DEVELOPMENT APPLICATION ASSESSMENT REPORT

Application Number:	DA2024/0606
----------------------------	-------------

Responsible Officer:	Lachlan Rose
Land to be developed (Address):	Lot 14 DP 10974, 13 Highview Avenue MANLY VALE NSW 2093
Proposed Development:	Alterations and additions to a dwelling house including garage and a swimming pool
Zoning:	Warringah LEP2011 - Land zoned R2 Low Density Residential
Development Permissible:	Yes
Existing Use Rights:	No
Consent Authority:	Northern Beaches Council
Land and Environment Court Action:	No
Owner:	Xiaodong Yu
Applicant:	JJ Drafting Australia Pty Ltd

Figure 1: Side setback non-compliance.

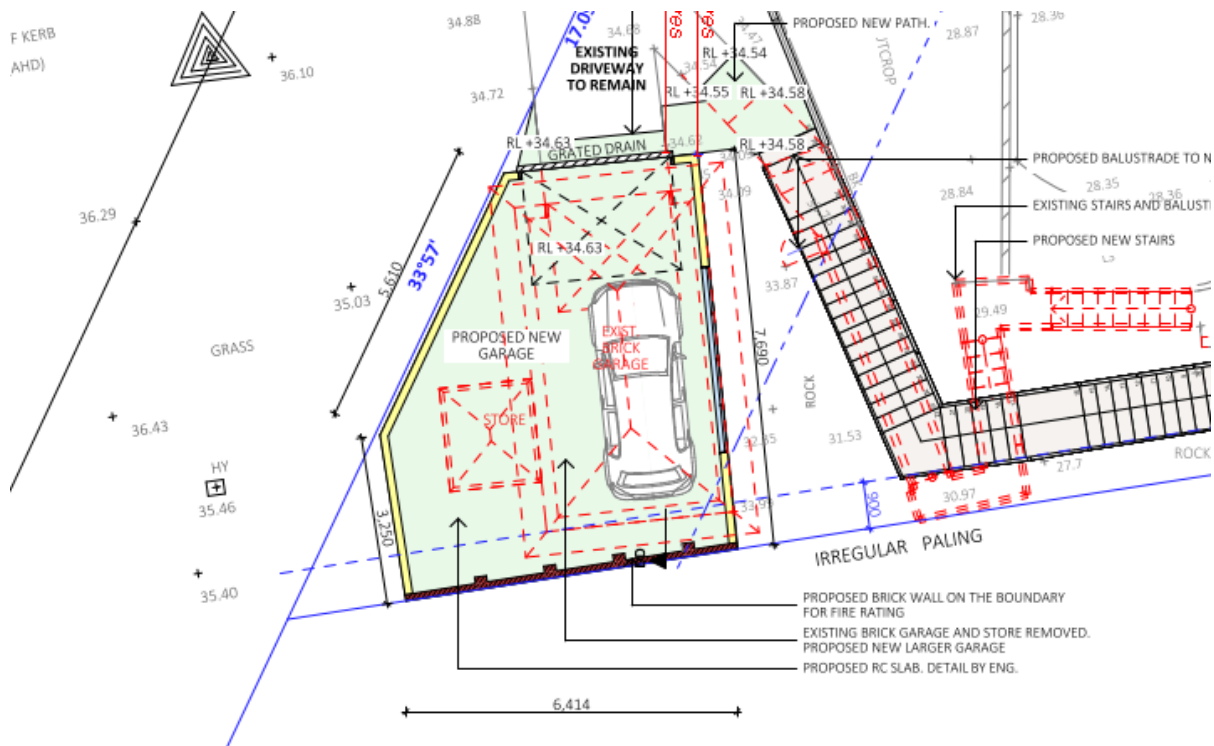
The proposed garage has a nil (0m) setback to the southern side setback and therefore, does not comply with the requirements above (1 & 2). See the figure below:

The landscaped open space of the side will comply with the requirements of Clause D1 Landscaped Open Space (LOS) and Bushland Setting and the proposal will provide opportunities for deep soil landscape areas.

A condition of consent will apply to this application to provide additional landscaping to the south-western corner of the proposed garage and front setback to reduce the visual dominance along the streetscape. The site is restricted by the steep topography from the front boundary to the dwelling house. In this circumstance, the garage is located in an adequate position with consideration to the restrictions of the site and will meet the existing streetscape character with multiple garages and carports within the front setback.

The subject site as an existing garage in a similar position as the new garage proposed. The increase in size of the proposed garage is to provide adequate parking space for a modern day car. The minor increase from the existing garage will not result in an unreasonable increase in scale and bulk.

The proposed garage will not result in unreasonable privacy, amenity and solar access impacts. There is an existing carport and garage to the south of the garage. The increase from the existing garage to the front and side setback which will not comprise of additional impacts to the above factors.

Having regard to the above assessment, it is concluded that the proposed development is consistent with the relevant objectives of WDCP and the objectives specified in s1.3 of the Environmental Planning and Assessment Act, 1979. Accordingly, this assessment finds that the proposal is supported, in this particular circumstance.
